CHANGE NOTIFICATION

PCN# 081815

Subject: Notification of Lead Frame Change to S8E Package

Lower Standoff SOIC 8L Exposed Pad

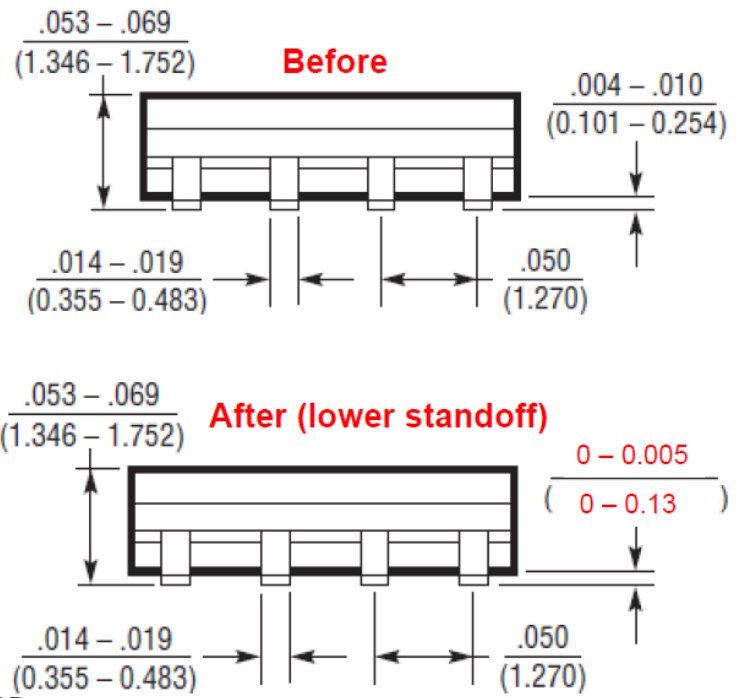
Product performance and specifications are not affected by this change in material, however the package standoff of the S8E package is being reduced to better match the standoff of the MSOP and TSSOP exposed-pad packages as shown in attached figure.
